**TO:** Sydney Central City Planning Panel – 10 June 2021

**SUBJECT:** Lots 12 & 13 Butu Wargun Drive PEMULWUY NSW 2145

**APPLICATION No:** MOD2020/0373

Figure 5 - Site Plan showing proposed deletion of internal roads dashed in blue (Drawing No. S01, Issue I, prepared by Architex, dated 14/05/2021)

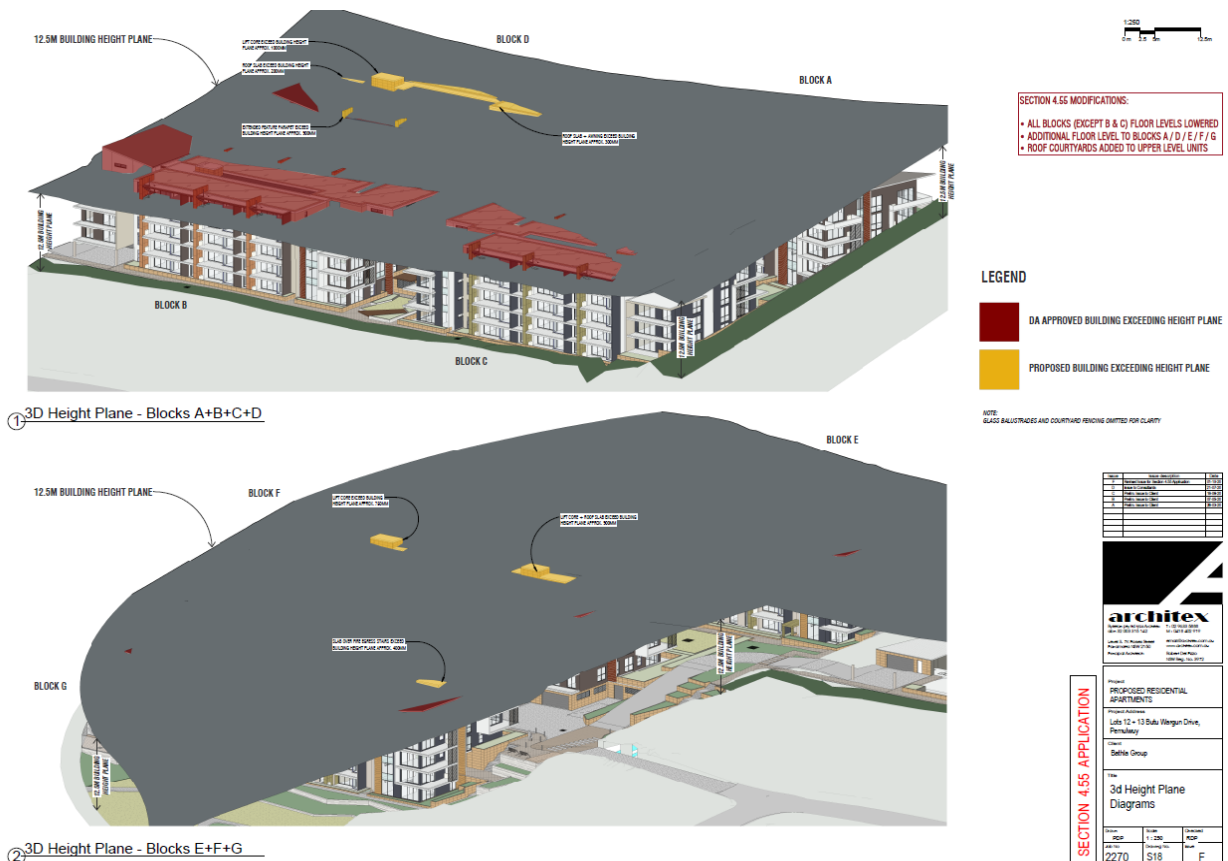
The development application was referred to Council's Development Engineer for comment who has advised that the modified development is supportable with regards to the deletion

of the internal roads and stormwater management, subject to the imposition of conditions requiring 2 loading bays to be provided for Blocks A-D & Blocks E-G, and the provision of a turning bay for a HRV at the entrance of Blocks E-G basement.

Figure 7 - 3D Height Plane Diagram showing height exceedance (Drawing No. S18, Issue F, prepared by Architex, dated 1/10/2020)

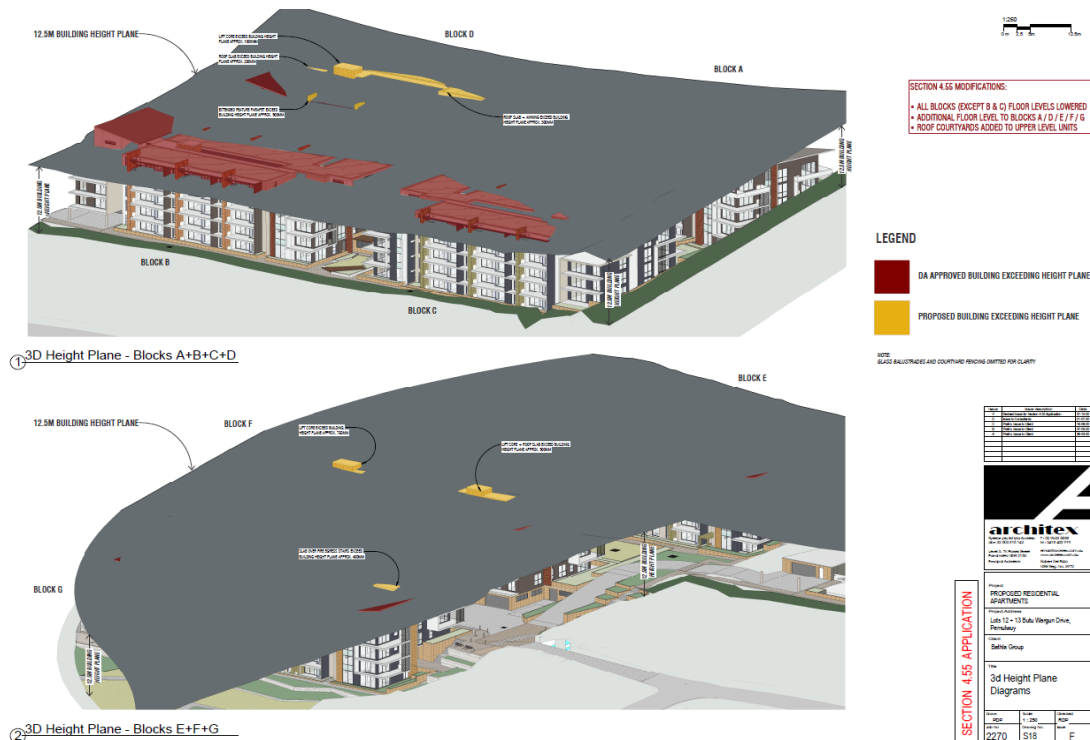
The modified proposal seeks the following breaches to the maximum 12.5m building height standard:

It is noted that the original application (DA2016/381/1) approved the following building height exceedance shown in red in Figure 7 below. The subject modification application seeks a further non-compliance to the maximum 12.5m building height standard shown in yellow below.

The variations sought as part of the subject application are minor, ranging from:

- 0.3m or 2.4% to 1m or 8% for Building D,
- 0.75m or 6% to 0.9m or 7.2% for Building F, and
- 0.4m or 3.2% for Building G.

The departures sought to the building height standard are restricted to the lift core, roof slabs and parapet features of the buildings, and do not include any habitable or additional gross floor area. The variation to the building height are primarily associated with the significant slope of the site.

Figure 8 - Site Section Plan showing building envelope approved by DA2016/381/1 hatched in purple and portions of modified proposal exceeding the 12.5m height standard (Drawing No. S17, Issue I, prepared by Architex, dated 14/05/2021)

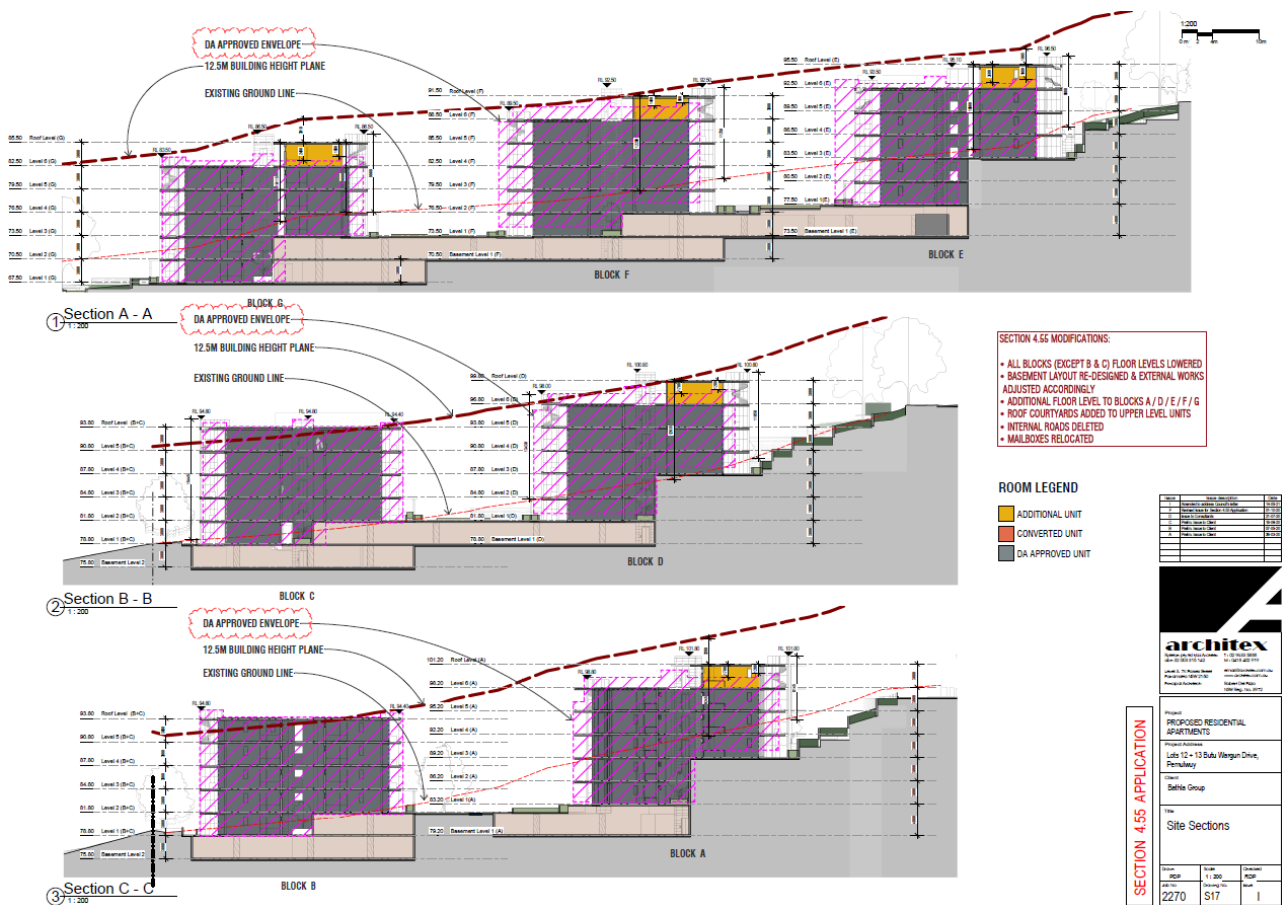
The amended proposal has lowered the floor levels of Blocks A, D, E, F & G to reduce the extent of building area that exceeds the height standard and to bring the buildings generally in line with the site specific RLs prescribed by Figure 55 Height Control Strategy – Pemulwuy South in Part P of HDCP 2013, as shown below.

South Elevation - Blocks A + B

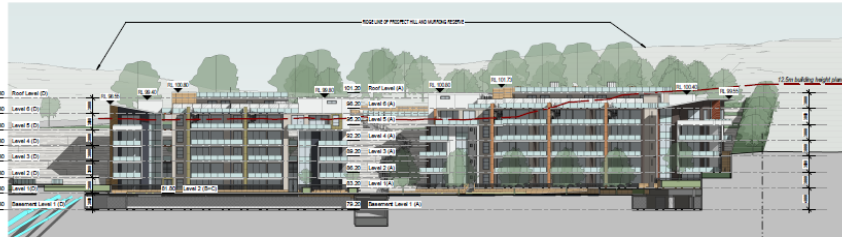
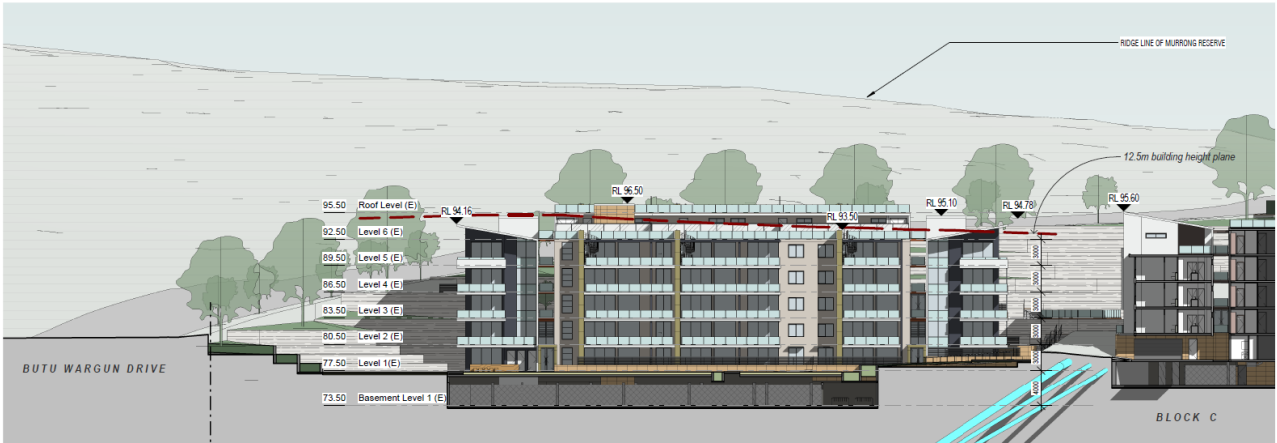
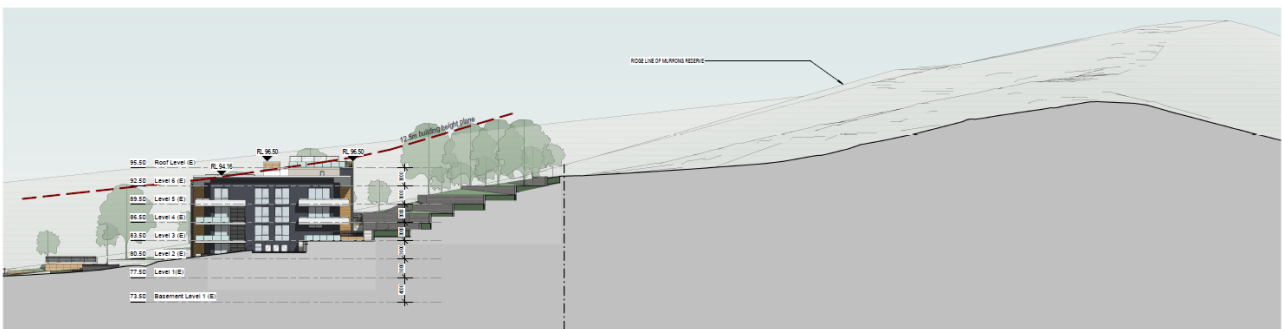
Elevation plans have been amended to show the ridgeline of Prospect Hill to determine the visual impact of the increased building height of the proposal.

The views from Prospect Hill to the east are not affected as a result of the proposal as the floor levels of Blocks A, D, E, F & G have been lowered, and additional floor levels have been included on the western end of blocks to fall within the 12.5m building height plane and respond to the steep topography of the land.

It is considered that the ridgeline of Prospect Hill is maintained from the 8 key vantage points identified in the Prospect Hill Conservation Management Plan, evident by the elevation plans and 3D aerial view plan submitted.
